Road Safety Audit

Lucan to City Centre

Core Bus Corridor Scheme
Stage 1 Road Safety Audit Report

Date September 2022

Drawing(s): BCIDA-ACM-TSM_SJ-0006_XX_00-DR-TR-0009, 0013 & 0016 of 16

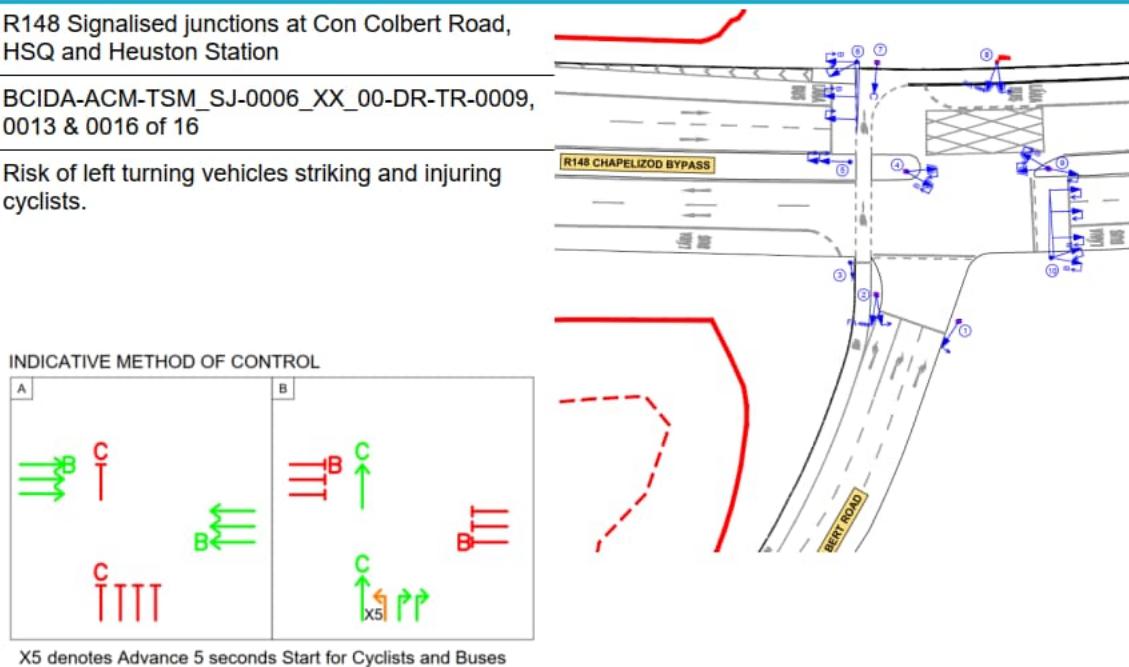
Summary: Risk of left turning vehicles striking and injuring cyclists.

There are signalised junctions on the R148 with the Con Colbert Road, HSQ and Heuston Station with left turn traffic manoeuvres conflicting with straight ahead cycle track movements. The traffic signals staging diagram is shown on drawing no. BCIDA-ACM-TSM_SJ-0006_XX_00-DR-TR-0009, 0013 & 0016 respectively. These indicate 2 no. signal phases, A and B. The left turn manoeuvre from Con Colbert Road, R148 westbound into HSQ and into Heuston Station, are indicated as 'X5' which denotes an Advance 5 seconds Start for Cyclists and Buses'.

Provide appropriate traffic signal stages and timings to accommodate all traffic and NMU improvements at these junctions.

4.2.23	Yes	Yes		Cyclists will get a 5 second (X5) head start ahead of buses. System design updated to make this clear.	
4.2.24	Yes	Yes		Cycle signage not shown for clarity - to be added at detailed design stage

Drawing(s): BCIDA-ACM-GEO_GA-0006_XX_00-DR-CR-0020 of 31

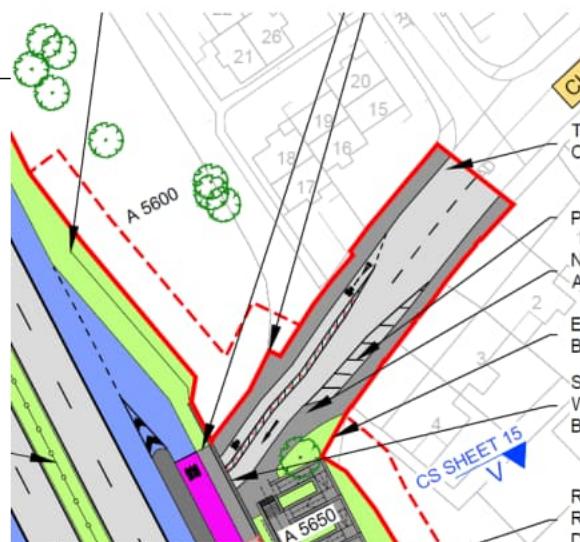
Summary: Risk of opposing cyclists collisions in uni-directional cycle track.

Provide appropriate cycle road markings and direction signage for all cyclists in both directions.

Drawing(s): BCIDA-ACM-GEO_GA-0006_XX_00-DR-CR-0026 & 0028 of 31

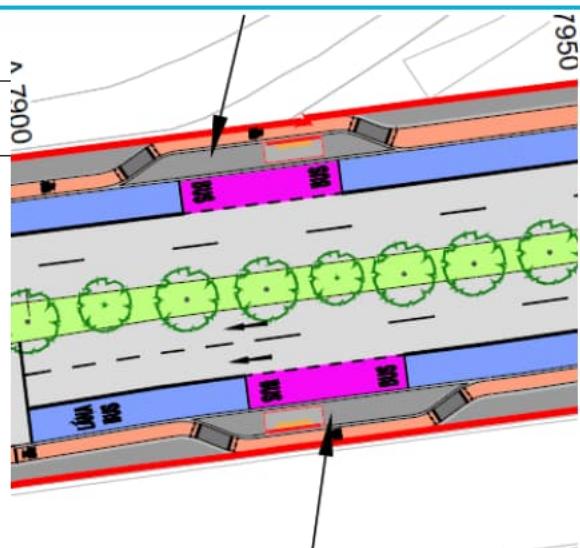
Summary: Risk of cyclists losing control due to geometry of cycleway, leading to falls.

Drawing(s): BCIDA-ACM-GEO_GA-0006_XX_00-DR-CR-0028 of 31

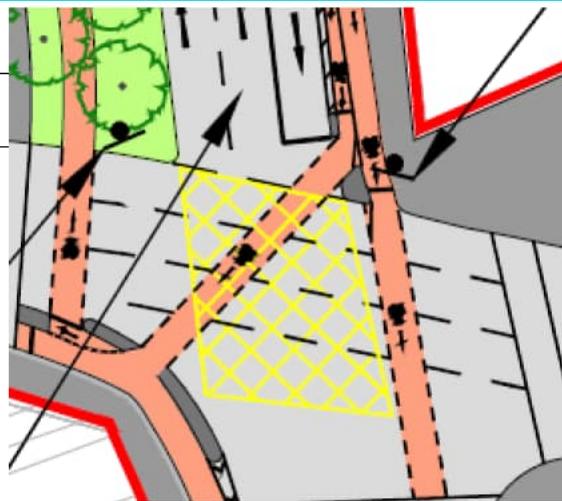
Summary: Yellow box road markings may lead to cyclist slips.

Remove the yellow box road marking across the cycle track or provide non-slip yellow box marking across the cycle track.

Design has been amended to provide shared landing bus stops.	
4.2.26	Yes	Yes		Yellow box road markings to be removed across the cycle lanes at detailed design stage.

Drawing(s): BCIDA-ACM-GEO_GA-0006_XX_00-DR-CR-0028 of 31

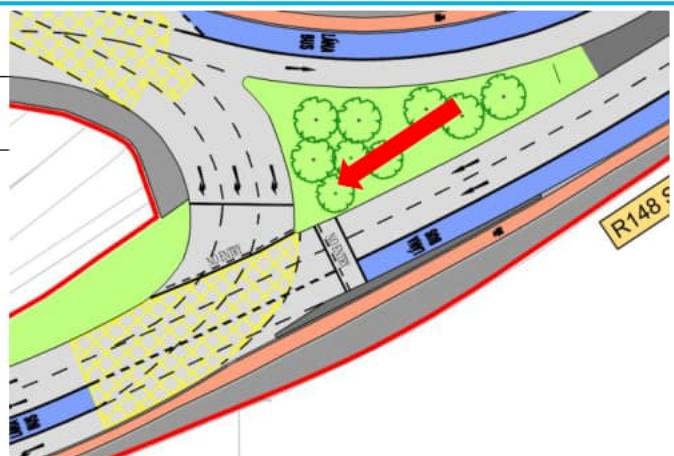
Summary: Vegetation blocking traffic signals can lead to vehicle collisions

Drawing(s): BCIDA-ACM-TSM_SJ-0006_XX_00-DR-TR-0016 of 16

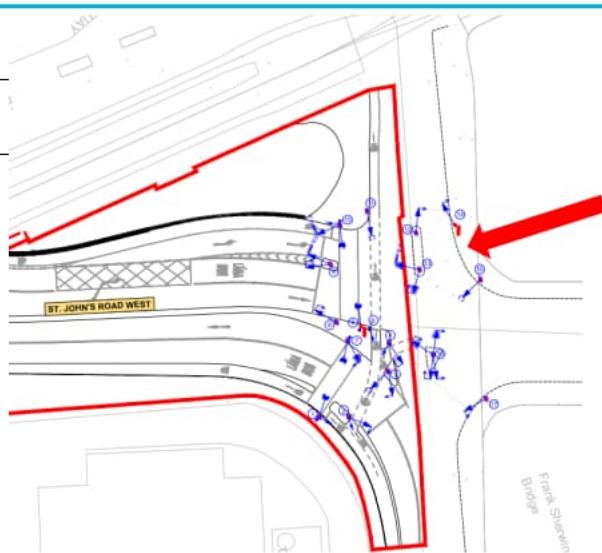
Summary: Lack of a pedestrian phase can lead to pedestrian collisions with vehicles.

The proposed traffic signals staging diagram is shown on drawing no. BCIDA-ACM-TSM_SJ-0006_XX_00-DR-TR-0016. No pedestrian crossing phase is shown on the proposed signal staging diagrams. It is unclear what pedestrian crossing facilities will be provided for footpath users crossing the Heuston Station access road to/from the Frank Sherwin Bridge to/from Heuston Station. There is a risk that pedestrians may cross the Heuston Station access road at a location where it is unsafe to do so which may result in pedestrian collisions with vehicles or cyclists.

Provide pedestrian facilities for footpath users to safely cross the Heuston Station access road to/from the Frank Sherwin Bridge.
